Project	IEEE 802.16 Broadband Wireless Access Working Group < http://ieee802.org/16 >	
Title	Bitmap in DCD for DL PUSC	
Date Submitted	2004-11-04	
Source(s)	Jeongheon Kim, Seungjoo Maeng, Panyuh Joo, Jaeho Jeon	jeongheon.kim@samsung.com sjmaeng@samsung.com panyuh@samsung.com jhjeon@samsung.com
	Samsung Electronics Co., Ltd. Dong Suwon P.O.Box 105 416, Maetan-3dong, Yeongtong-gu, Suwon-city, Gyeonggi-do, Korea 442-600	
Re:		
Abstract	Used channel bitmap for DL PUSC in DCD	
Purpose	Adopting of proposed method into P802.16e	
Notice	This document has been prepared to assist IEEE 802.16. It is offered as a basis for discussion and is not binding on the contributing individual(s) or organization(s). The material in this document is subject to change in form and content after further study. The contributor(s) reserve(s) the right to add, amend or withdraw material contained herein.	
Release	The contributor grants a free, irrevocable license to the IEEE to incorporate material contained in this contribution, and any modifications thereof, in the creation of an IEEE Standards publication; to copyright in the IEEE's name any IEEE Standards publication even though it may include portions of t

Figure 1. Possible usage of DL PUSC zone

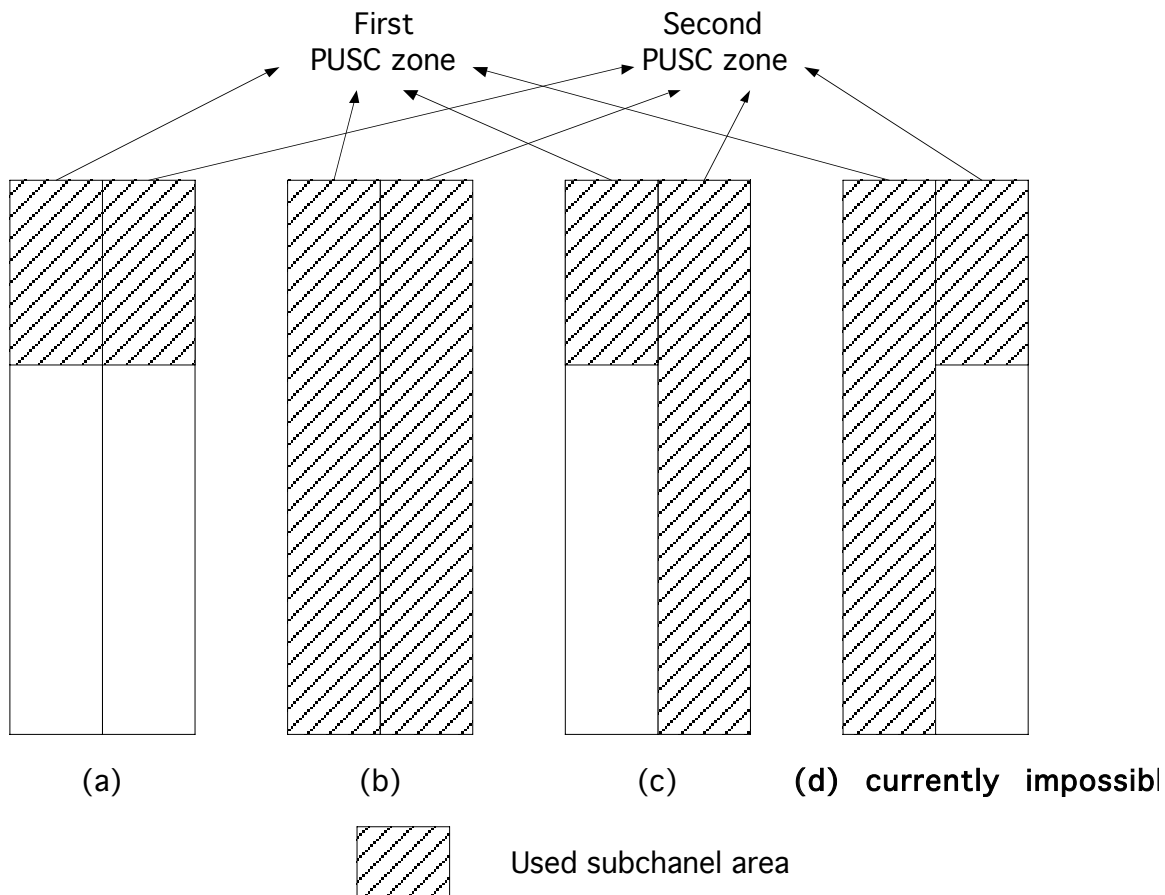
There is a field “Used subchannel bitmap” in FCH to indicate which subchannels are used in first DL PUSC zone. If “with all subcarriers” indicator in Zone_Switch_IE is turned on, then PUSC zone will be used with all subchannels regardless of the value of “Used subchannel bitmap”. Otherwise PUSC zone will be used only with the subchannels specified by “Used subchannel bitmap”. But when “Used subchannel bitmap” in FCH indicates that all the subchannels are used in DL PUSC, there is no way to use PUSC with partial subchannels in that frame. In Figure 1, all possible combination of DL PUSC zone usage is depicted. Currently all combinations are supported except (d). In this contribution, we propose to insert bitmap similar to “Used subchannel bitmap” in DCD to support usage of PUSC like (d). Using the proposed bitmap in DCD, we can use DL PUSC with partial subchannels even if the “Used subchannel bitmap” in FCH indicates that all subchannels are used in the first PUSC zone.

For PUSC permutation, if the “Used subchannel bitmap” field in FCH indicates that all the subchannels are

used and “Use all SC indicator” is 0, then subchannels indicated by “Used subchannel bitmap for DL PUSC” in DCD shall be used.
